## Comhairle Contae Chill Dara Kildare County Council

### **Proposed New Pedestrian/Cycle Bridge, Celbridge, Co Kildare.**

### **Part VIII Submissions Report.**

**July 2022**

Figure 2.1 – Pedestrian/Cyclist Bridge

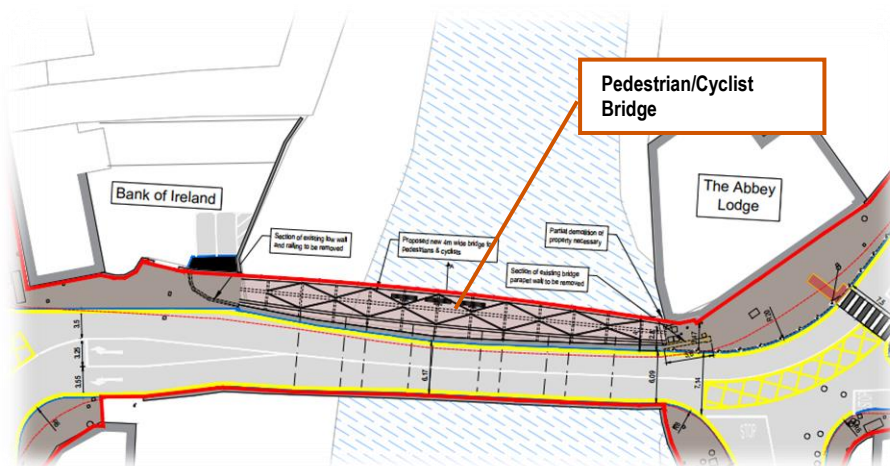
It is welcomed that the proposed bridge provides a 4m wide path to provide sufficient width for both pedestrians and cyclists.

The current bridge provides only for on-road cycling with cyclists mixing with traffic in a constrained location which is off-putting for all except for the experienced cyclists.

The proposal to have a wide shared path over the bridge gives nervous and younger cyclists a safe location to cross the bridge and it is essential that this 4m wide path is retained as part of the scheme.

Figure 2.2 – Main Street Proposed Controlled Pedestrian Crossing

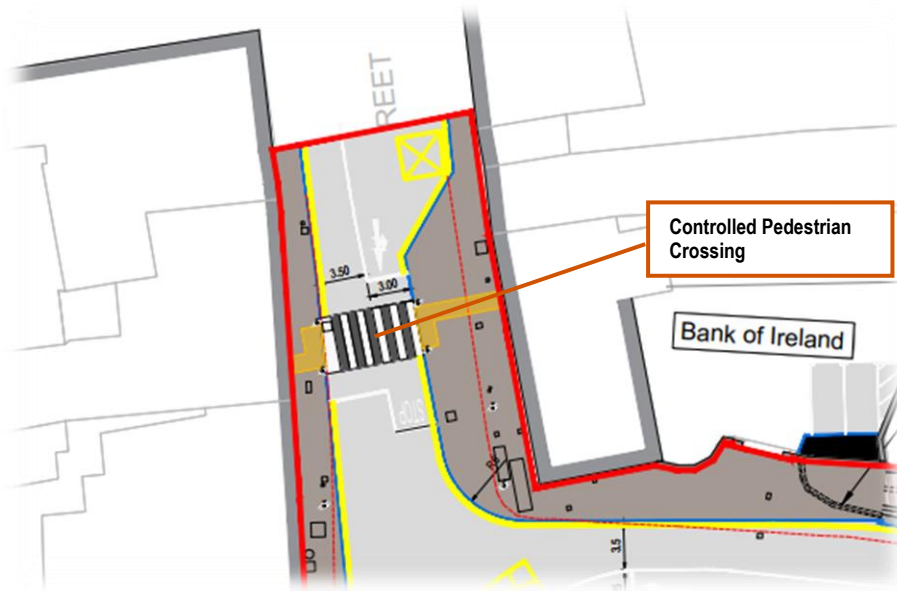
The proposal to add a new controlled pedestrian crossing at the southern end of Main Street is welcomed as it facilitates a key desire line for pedestrians to cross at this location.

The benefits of providing a safe crossing at this pedestrian desire line far outweigh any negligible impact on traffic movements at this junction and it is essential that this element is retained as part of the scheme.

To prepare drivers for this change during the upcoming summer months the current left turning lane should be close to traffic.

Figure 2.3 – Kerb Build-out at Abbey Lodge

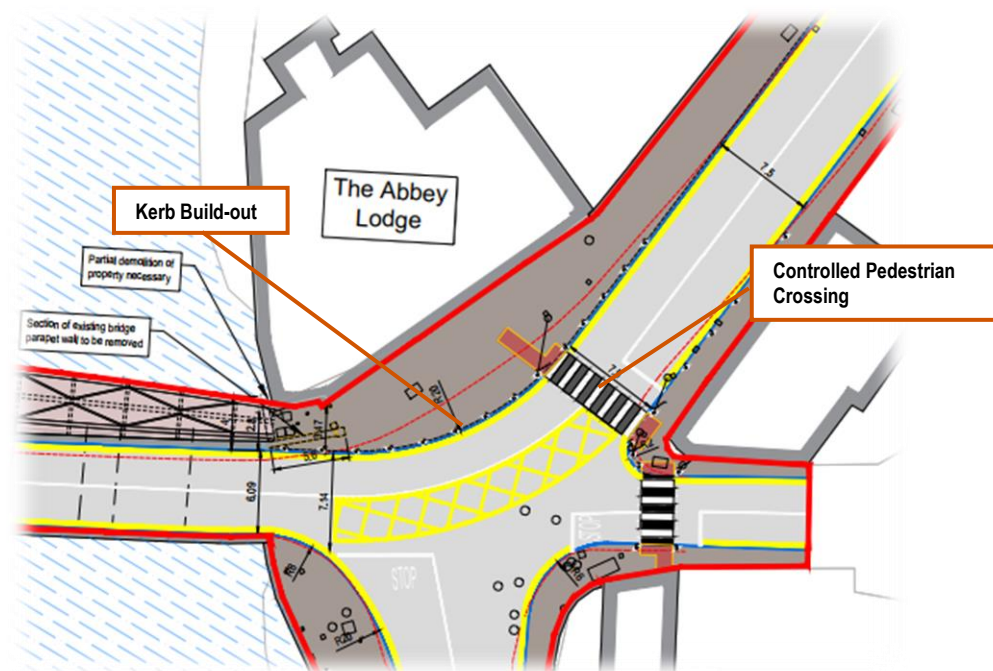
The proposal to provide a kerb buildout at this location is welcomed as it will slow vehicles speeds by reducing the radius at the bend and narrowing the lane width. It also provides improved visibility for the eastbound drivers driving over the bridge of the entire pedestrian crossing to be able to stop safely to allow pedestrians to cross.

The safety improvements of this kerb buildout will assist in reducing conflicts at this location and for road safety reasons alone it is essential that this element is retained as part of the scheme.

Figure 2.4 – Kerb Build-out at Bridge House

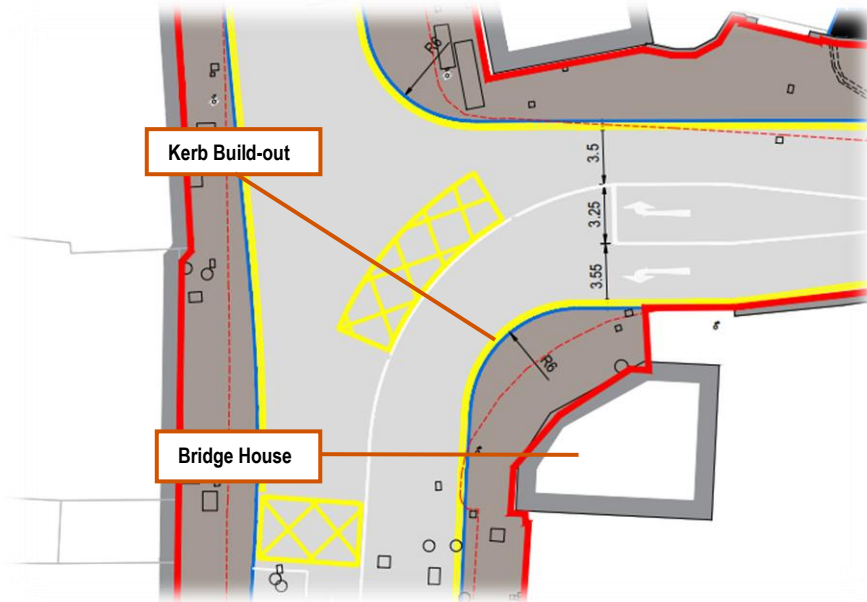
The proposed radius reduction at the corner of Bridge House may be too small and lead to larger vehicle (bus) to cross into the opposing lane leading to side swipe vehicle collisions.

Vehicle tracking of the bend should be carried out for a large vehicle and the kerb line amended or the centreline relocated as deemed appropriate.

Figure 2.5 – Right Turing Bay Layout

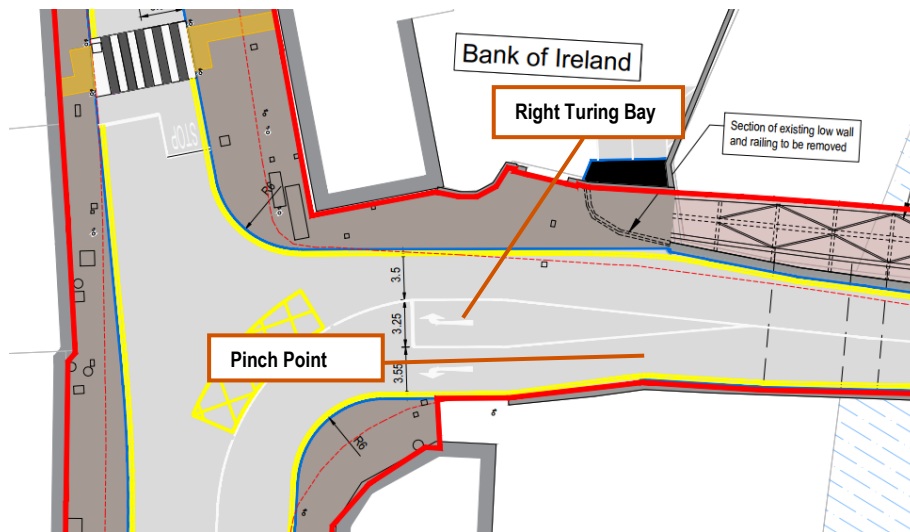
The right turning bay layout generates a pinch point on the west bound lane over the bridge, this could lead to vehicles clipping the parapet wall or another vehicle waiting to turn right onto Main Street.

As the design progresses the layout of the right turning bay should be amended to ensure consistent lane width is provided on both the eastbound and westbound lane of the bridge.

Figure 2.6 – Carriageway Width on Approach to Bridge

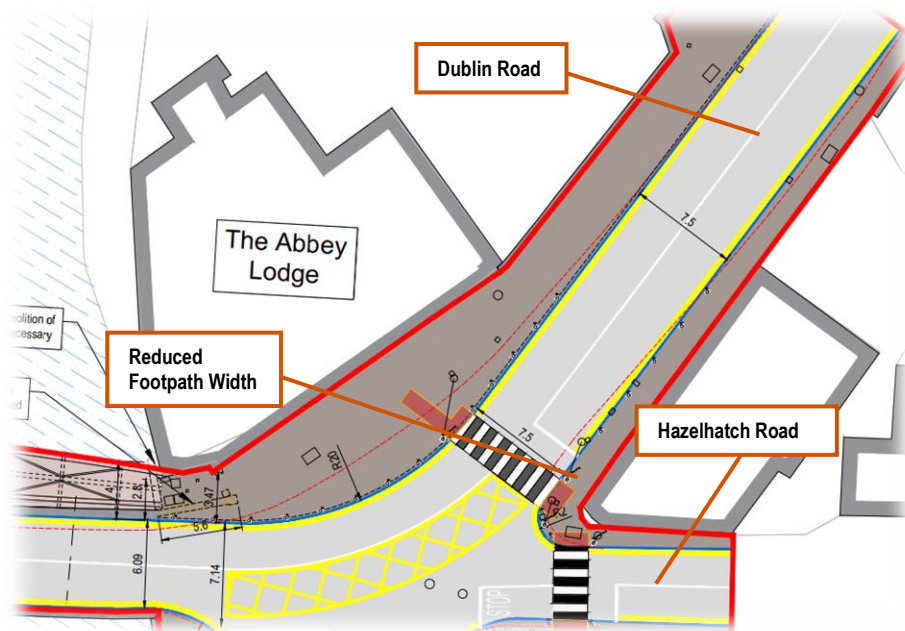
As the design progresses consideration should be given to reducing the carriageway width on the Dublin Road to be in line with DMURS (Design manual for Urban Roads and Streets) carriageway width proposals for an urban link street of 6 to 6.5m.

Adopting a reduced carraway width will have the benefit of reducing vehicles speeds and will provide space to the widen the footpath on the eastern side of Dublin Road and at the corner of corner of Dublin Road and Hazelhatch Road leading to a safer and more comfortable pedestrian environment.
